APPENDIX B
PUBLIC COMMENTS AND AGENCY RESPONSES

**Re: Draft Environmental Impact Statement for the Badger State Solar Project,
Jefferson County, Wisconsin – CEQ No. 20220027**

Re: DEIS USDA RUS Badger State Solar LLC's Alternating Current Solar Project, Jefferson County Wisconsin.

Figure 1: Viewshed Analysis for the Proposed Badger State Solar Project Site

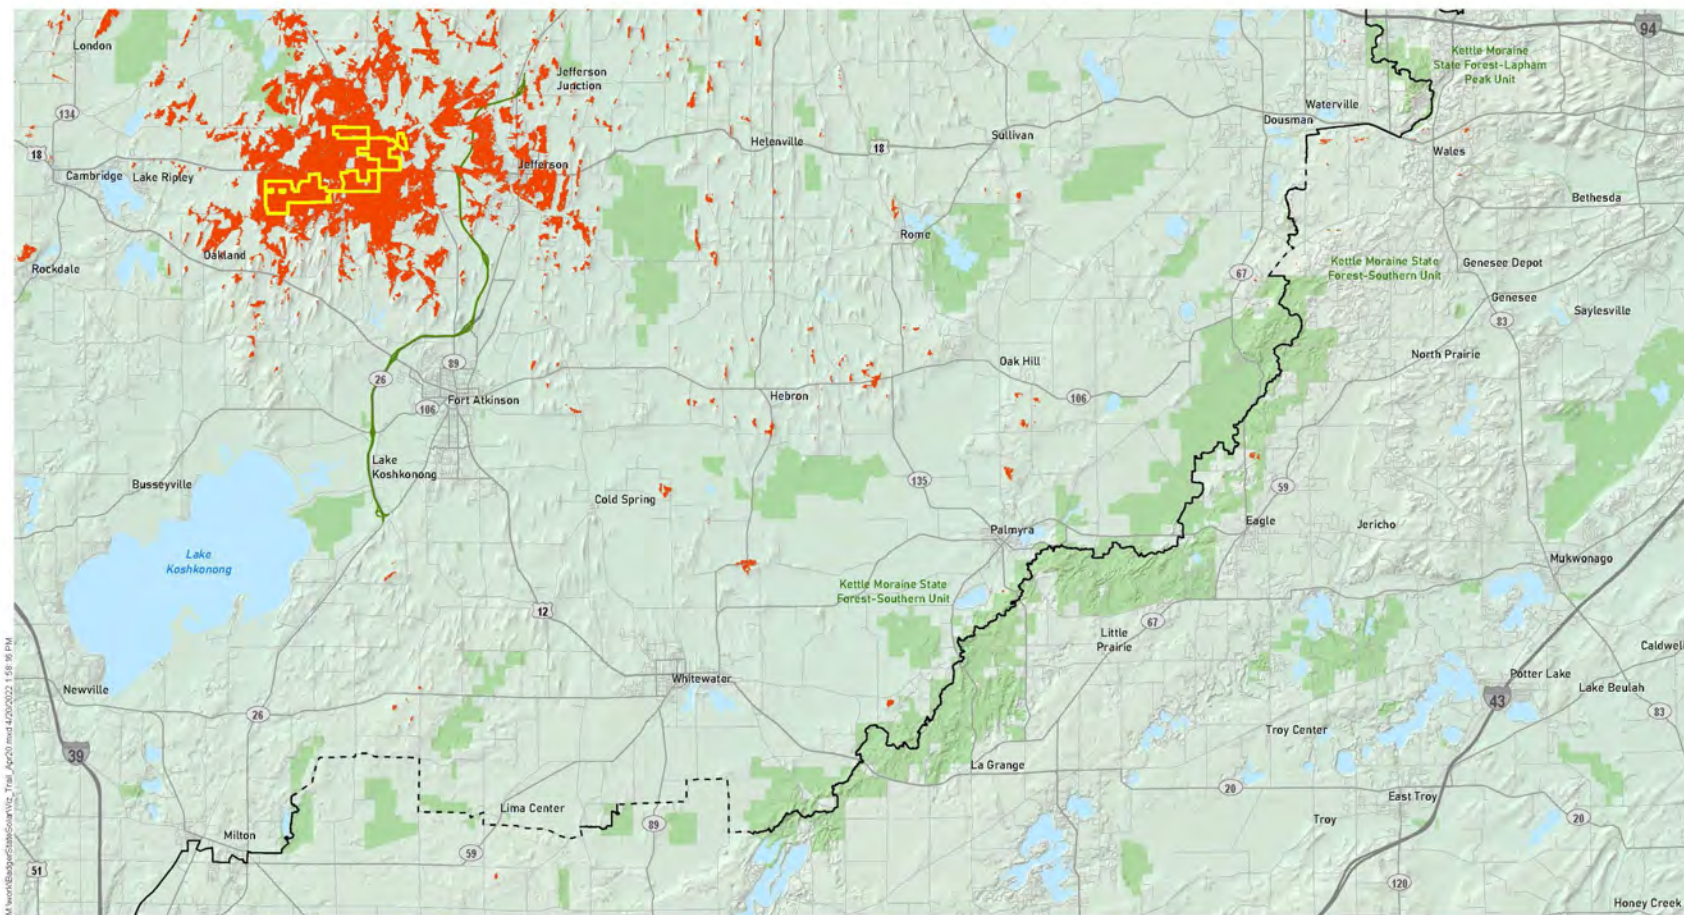
The NPS expressed concern about the Project's potential visibility, specifically from higher vantage points along the Ice Age National Scenic Trail (IATR) which is managed by the NPS. The IATR "roughly follows the spine of the interlobate moraine area of the Southern Kettle Moraine in a Southwest/Northeast alignment." The observation tower at Lapham Peak State Park is one of the higher vantage points along the trail with additional high points near the cities of Palmyra and Whitewater, WI.

The NPS requested additional information about the Project location and reflection and additional analysis regarding potential effects. The NPS also requested that a map displaying the location of the IATR in relation to the proposed Badger State Solar Project be included as part of the Final EIS. Finally, NPS requested additional consultation with RUS to ensure the viewsheds from the IATR and potential impacts to visual resources are considered and mitigated or eliminated if possible.

The Rural Utilities Service (RUS) appreciates the NPS input regarding the proposed Badger State Solar Project. RUS has expanded the viewshed analysis in the EIS to evaluate whether the proposed Badger State Solar Project would be visible from the IATR. The IATR is located approximately 12 to 20 miles to the east, southeast, and south of the proposed Project site, and at an overall higher elevation than the Project Site. The attached Figure 1 shows the location of the IATR in relation to the proposed Project site, and the results of the viewshed analysis. While the Project Site would potentially be visible from select locations in the vicinity of the IATR, it should not

Figure 2. Viewshed Analysis for Lapham State Park Observation Tower

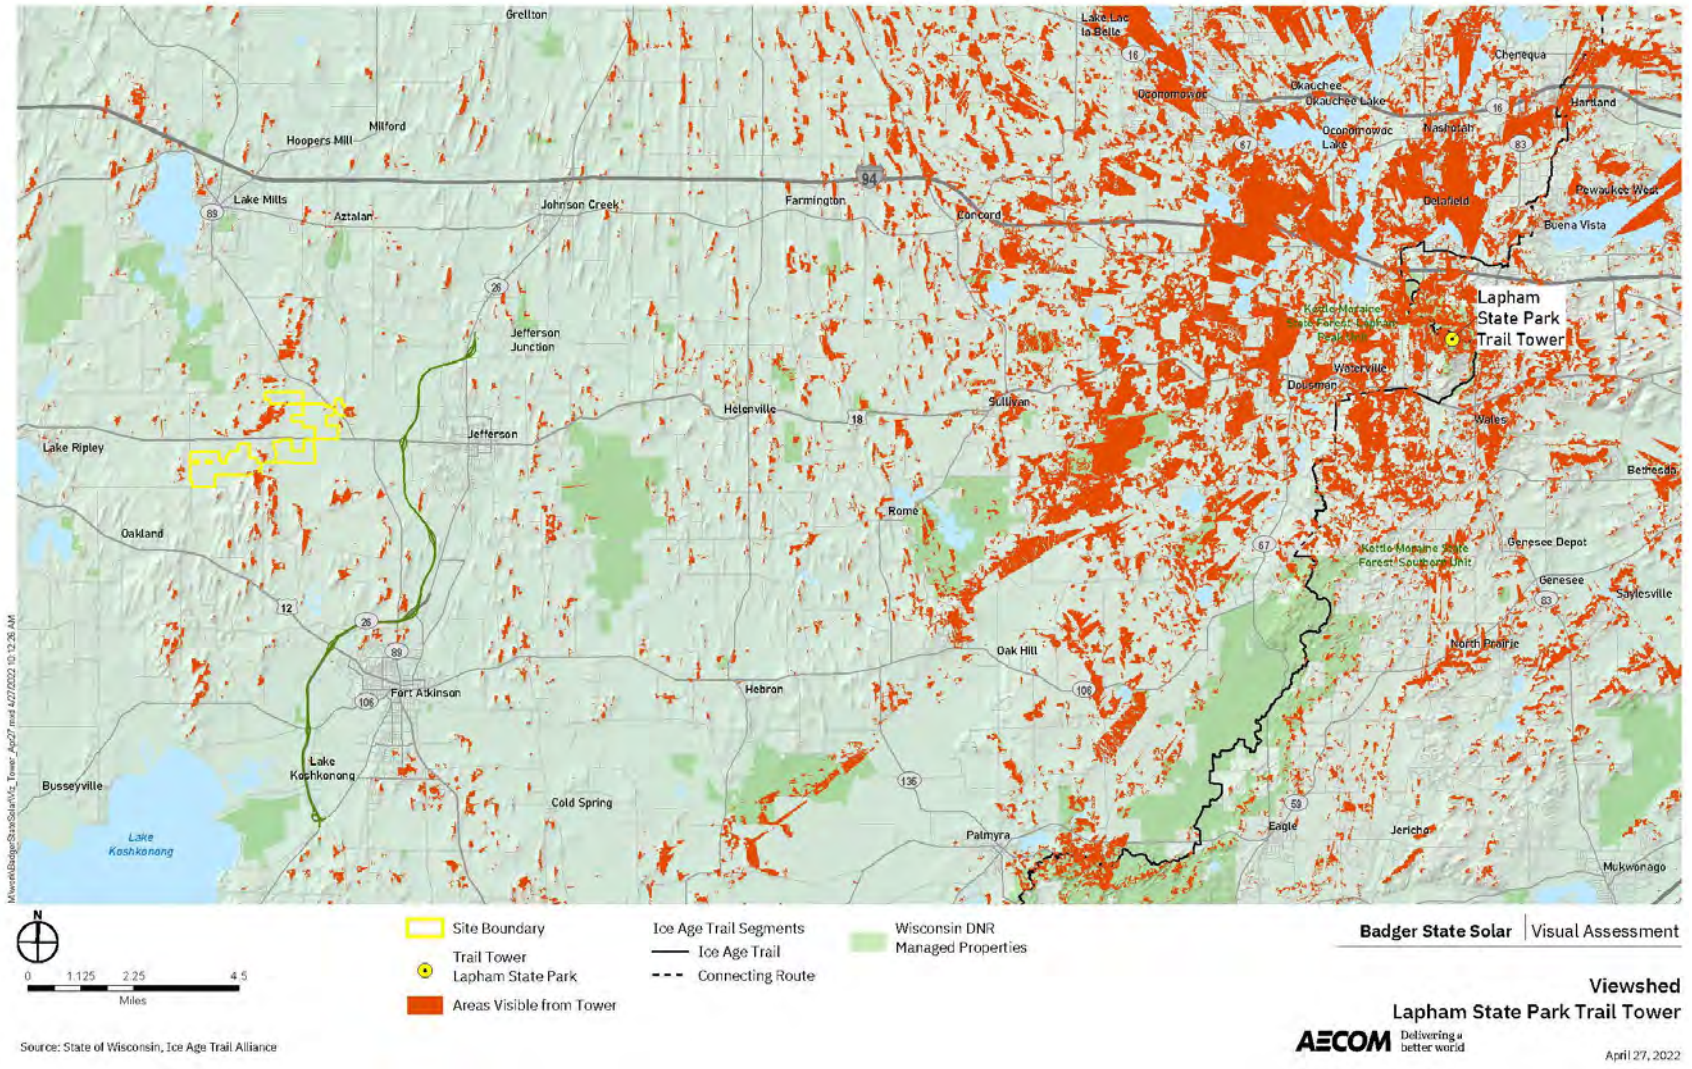
Due to the many geologic features, the NPS is concerned that placing solar panels at this location has the potential to impact visual resources and requests additional information about project location and reflection be provided so that additional analysis can be undertaken to determine potential affects. The DEIS currently does not contain a map displaying the location of the IATR in relationship to the project area; such a map should be included as part of the final EIS.

be visible from any point on the IATR itself. The attached Figure 2 shows the location of the observation tower at Lapham State Park and a viewshed analysis looking outward from the tower. As shown on the inset map, a few small and isolated portions of the Project Site may be visible from the top of the tower. The distance from the tower to the nearest portion of the Project site that might be visible from the tower is 23.6 miles. These areas would represent a negligible portion of the viewshed.

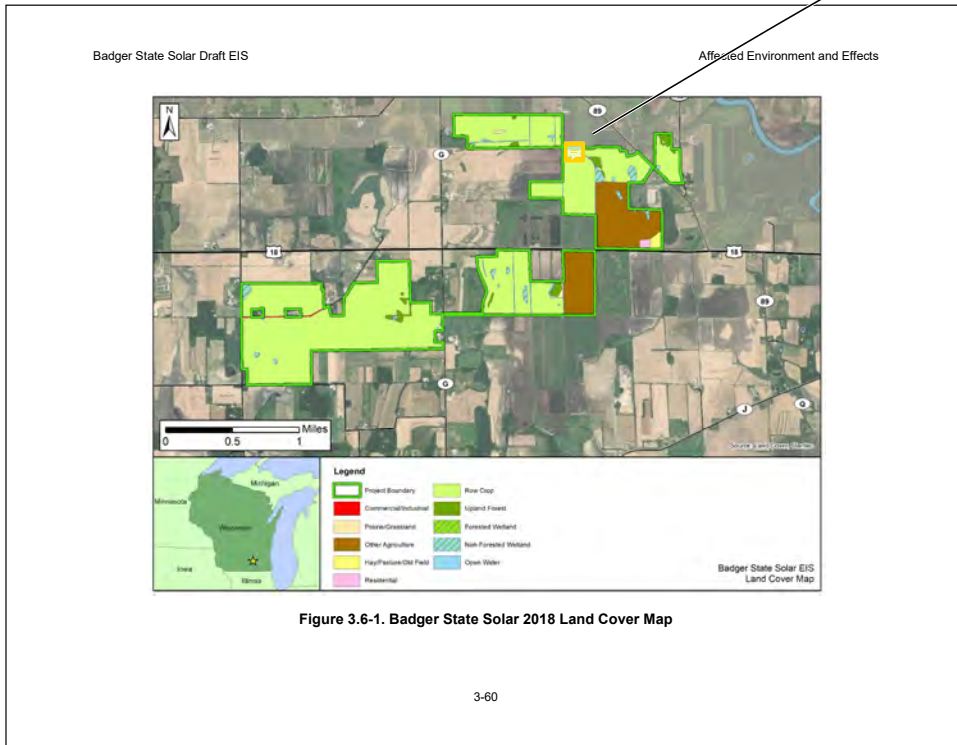
In Figure 3.6-1, at this scale some of the non-forested wetlands appear to be mapped as open water since the symbol of the green diagonal lines do not show up.

Author: jkamm Subject: Sticky Note Date: 3/18/2022 11:43:28 AM
At this scale some of the non-forested wetlands appear to be mapped as open water since they symbol of the green diagonal lines do not show up.

Response: The color of open water in Figure 3.6-1 was changed to provide greater distinction between open water and non-forested wetlands.
